Proposal No. 608051-132406

ADDENDUM NO. 5

**Federal Aid Project No. STP/CMQ/HSI-0034(030)X
Reconstruction on Route 38 (Main Street), from Route 62 to the Woburn C.L.**

Questions and Responses

FACE OF SIDEWALK CURB DETAILS

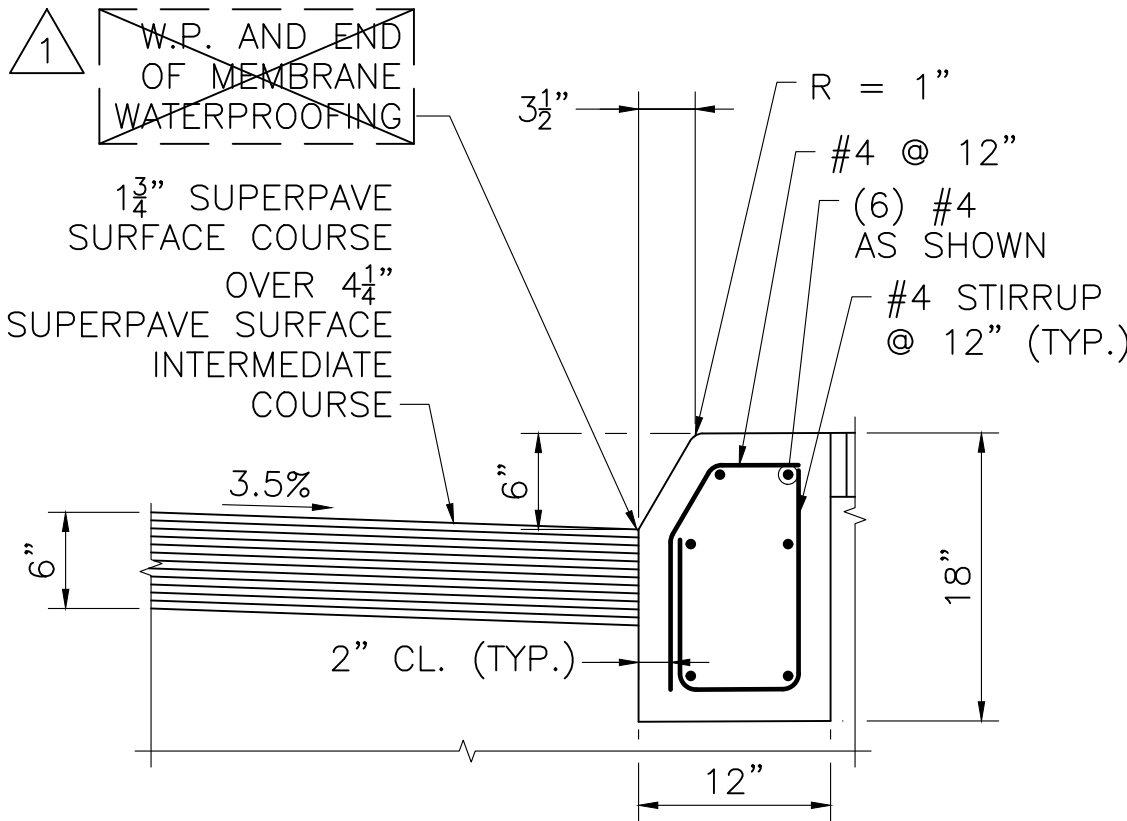
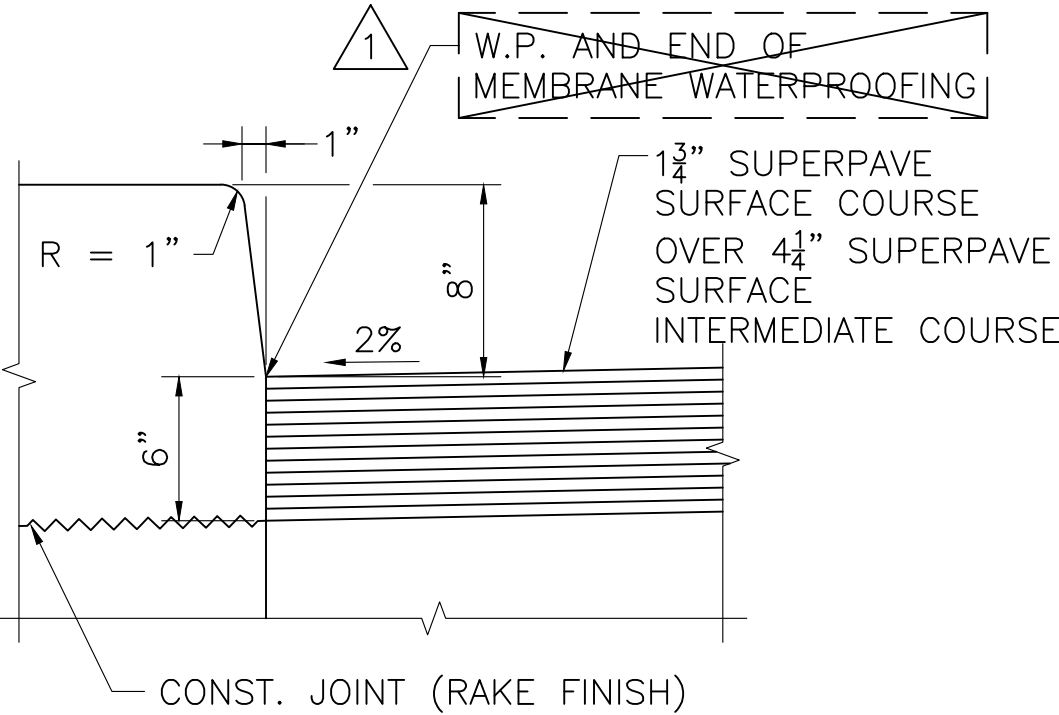
Question 31) Please reference plan sheet 255 (Bridge Sheet 20/26). The details for the "Face of Sidewalk Curb Details" and the "Face of Safety Curb Details" appear to indicate that the Membrane Waterproofing will be installed below the Superpave Intermediate course, and therefore above the Superpave Base Course. Please clarify if these limits of the Membrane Waterproofing are correct, or if the Membrane Waterproofing should be on the Precast Frame/CDF (below the Superpave Base Course).

Response 31) See the revised Plans Sheet 255 and 256. Membrane waterproofing to be removed from the two details noted on Sheet 20. The membrane waterproofing will be applied to the precast frame as called out in the Typical Section and on Sheet 21.
